MONTEREY PENINSULA WATER MANAGEMENT DISTRICT

ADDENDUM NO. 2 TO CONTRACT DOCUMENTS

For Construction Of SANTA MARGARITA WATER TREATMENT FACILITY PROJECT

FILE NAME: 18014.2 A101

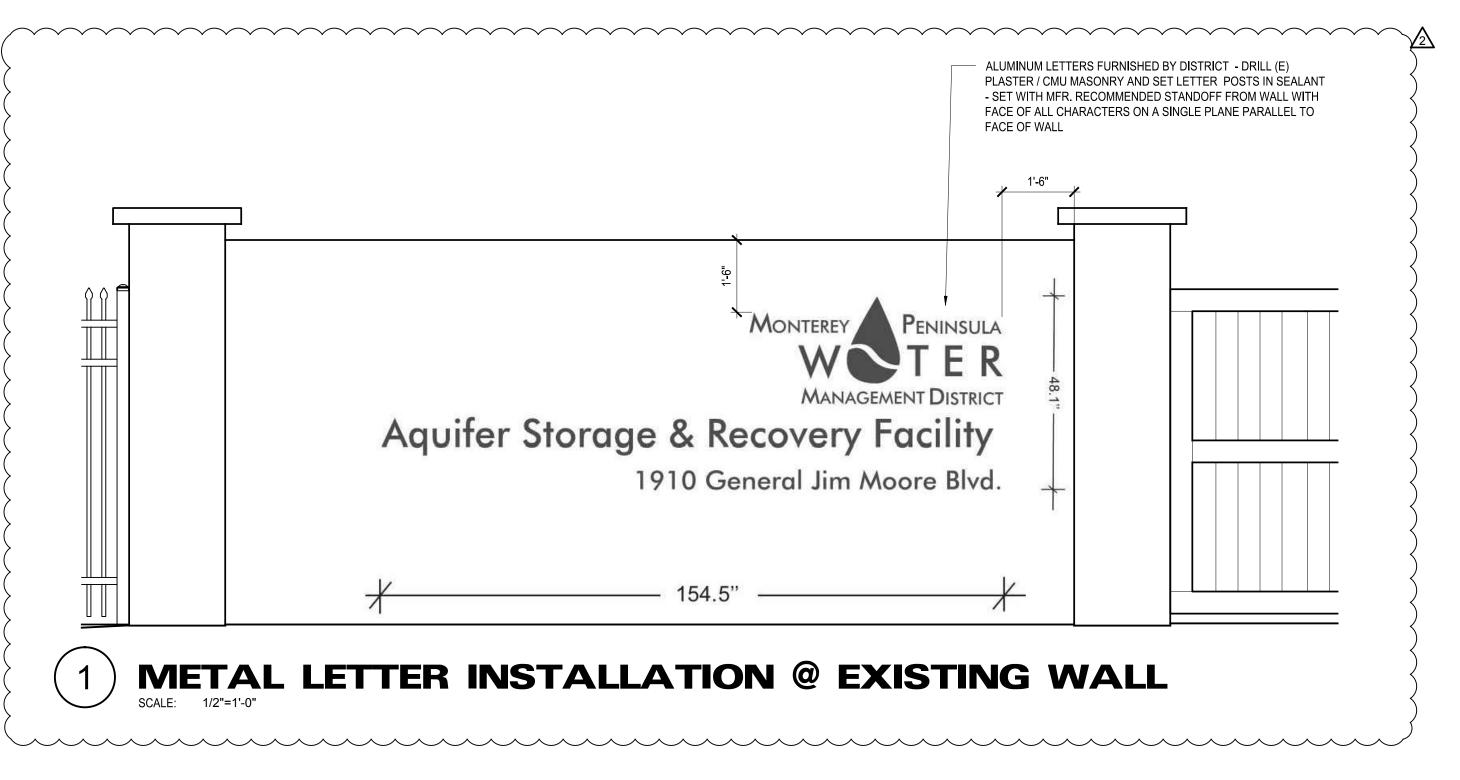
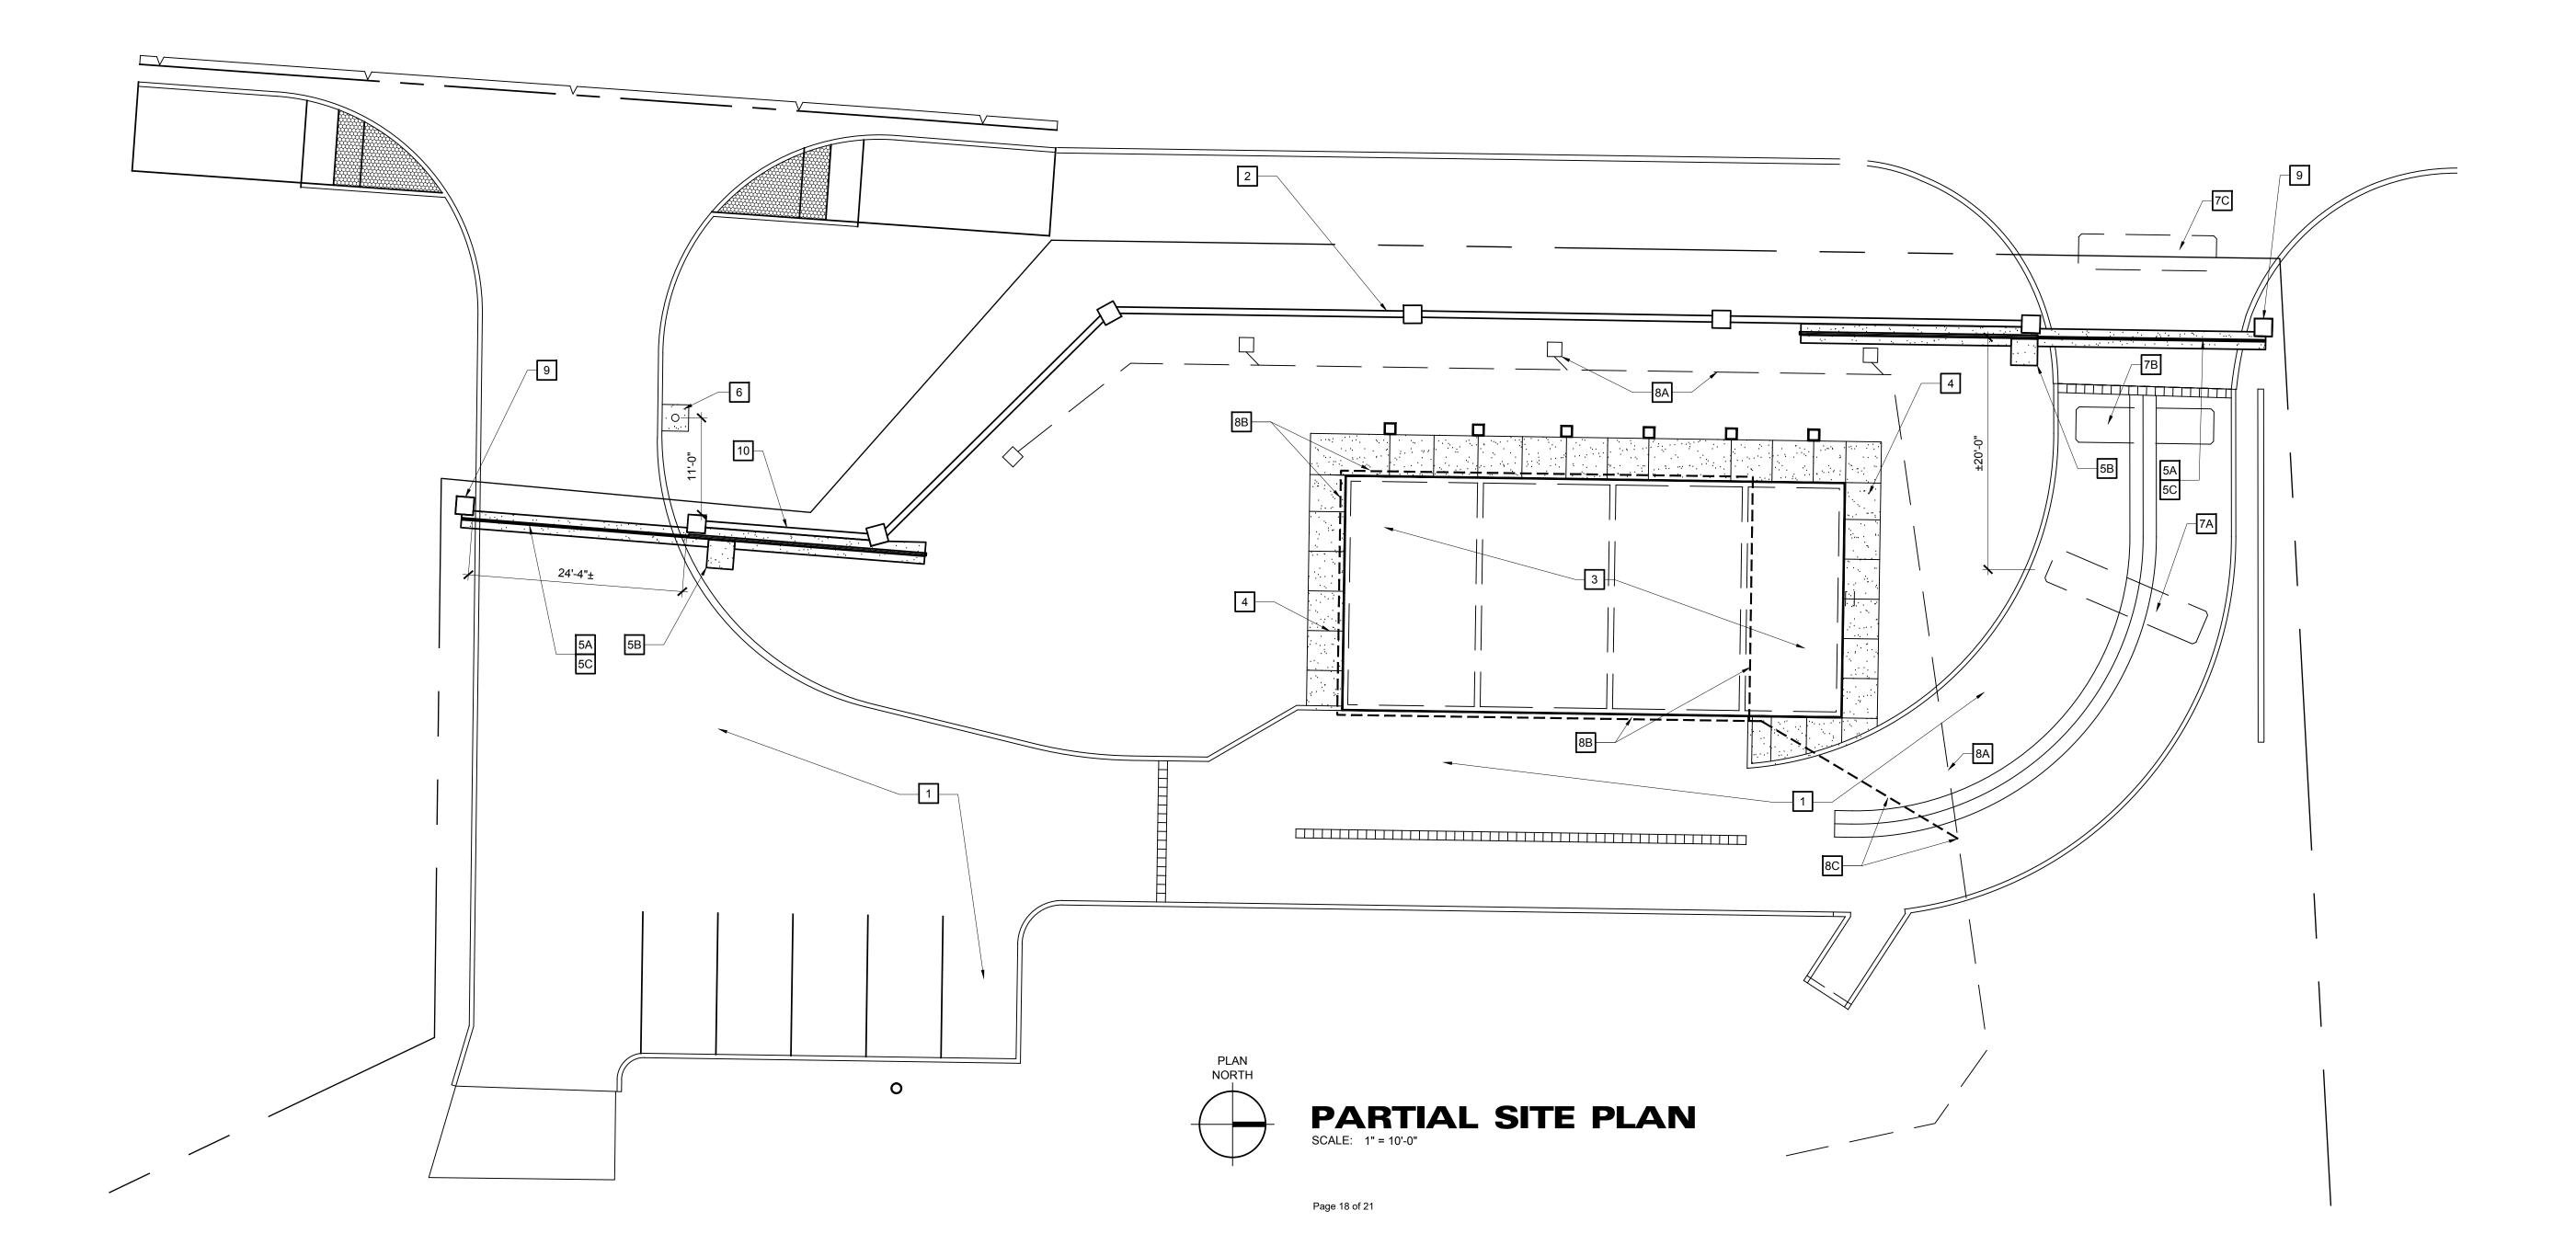
Delete drawings C7, C9, C10, C11, C13, A101, A111, and A401 and replace with the drawings supplied as Exhibit 2 to this Addendum 2.

KEY NOTES THE KEY NOTES THAT FOLLOW APPLY TO THE DRAWING(S) ON THIS SHEET ONLY. REFER TO FOLLOWING SHEETS FOR NOTES THAT ARE APPLICABLE TO THOSE DRAWINGS. 6 SLIDING GATE CONTROL - KEYPAD STATION NEW BUILDING ACCESS DRIVEWAY INCLUDING 5 PARKING SPACES 2 EXISTING WALL AND FENCING SLIDING-GATE CONTROL-SENSOR-LOOPS IN DRIVEWAY: EXIT LOOP, CAST IN NEW PAVING PER MFR. INSTUCTIONS 3 NEW BUILDING 7B INSIDE SAFETY LOOP, CAST IN NEW PAVING PER MFR. INSTUCTIONS 4 NEW CONC. PAVING, SEE DETAIL 1/ A111 OUTSIDE SAFETY LOOP, INSTALL IN SAWCUT KERFS IN (E) PAVING PER MFR. INSTUCTIONS 5 NEW ROLLING GATE CONCRETE / STEEL TRACK, SEE DETAIL 3/A111 GATE MOTOR ON CONCRETE PAD, SEE DETAIL 4/A111 8 FOUNDATION SUB DRAIN SYSTEM APPROXIMATE LOCATION OF EXISTING SITE AREA DRAIN SYSTEM 5C STEEL TUBE ROLLING GATE WITH WOOD CLADDING, SEE DETAILS 4/A111 AND 5/A111 NEW SUB DRAIN FOUNDATION PIPE, 4" PERFORATED SCHEDULE 40 PVC PIPE, SEE DETAIL 5/S4.0 FOR INVERT HEIGHT NEW SUB DRAIN DRAINAGE PIPE, 4" SOLID SCHEDULE 40 PVC PIPE, SLOPE 1% MIN. TO P.O.C. AT EXISTING AREA DRAIN SYSTEM PIPE, VERIFY EXACT LOCATION (E) INVERT FOR NEW DRAIN P.O.C. PRIOR TO PROCEEDING WITH ANY NEW DRAIN INSTALLATION WORK 9 NEW STAND ALONE COLUMN MATCHING CONSTRUCTION OF EXISTING PILASTER AT OPP. SIDE OF DRIVEWAY, SEE DETAIL 7/A111 INSTALL METAL LETTERS ON EXISTING WALL, METAL LETTERS FURNISHED BY DISTRICT, SEE ELEVATION 1/A101 (ON THIS SHEET)
